**Morrison Bros. Co.**  
325 E. 24<sup>th</sup> St.  
P.O. Box 238  
Dubuque, IA 52004-0238

Subject: Fig. 603 Tank Truck Emergency Valve - Replacement Parts

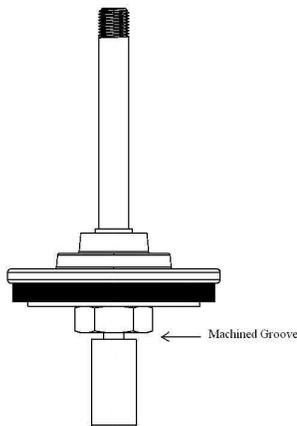
Our records indicate that your company has purchased our Fig. 603 Tank Truck Emergency valves. This letter is to inform you of some changes in the replacement parts we offer for these valves, specifically the plunger and the seal disc. In the past we sold Buna-N and Viton seal discs to replace ones that had become worn during service. Replacing these seal discs would require disassembly of the valve, disassembly of the plunger, removal of the old disc from the existing plunger, reassembly of the plunger with the new seal disc, then reassembly of the entire valve.

We now offer assembled plungers that come complete with all the plunger parts including a new seal disc. This convenient option eliminates the need for the repair technician to disassemble and reassemble the plunger and insures that the seal disc is properly assembled on the plunger. In addition to the convenience factor, we have also made a recent design change to the plunger itself. The newly designed plunger can be identified by a machined groove immediately below the disc nut. Please see the drawing below.

We are recommending that you replace any old style plungers, found during valve maintenance, with a new complete plunger. The part numbers and list prices for these new assembled plungers are:
